Device TC37x
Marking/Step (E)ES-AA, AA
Package see Data Sheet

10375AERRA

This Errata Sheet describes the deviations from the current user documentation.

Figure 10 Package Outlines LQFP-176 for TC37x

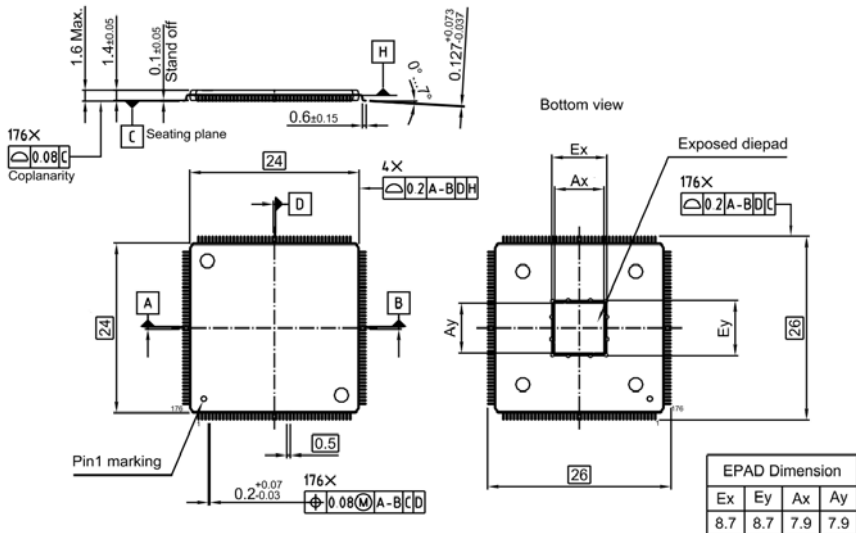
PACKAGE TC.H004 Exposed pad dimensions and package outlines for QFP packages - Updates to TC37x Data Sheet

In the scope of the harmonization of the package drawings, the drawings for the LQFP-176 package of the TC37x have been updated. No change of form, fit or function is implied.

This information shall substitute the corresponding information in the TC37x AA-step Data Sheet V1.1.
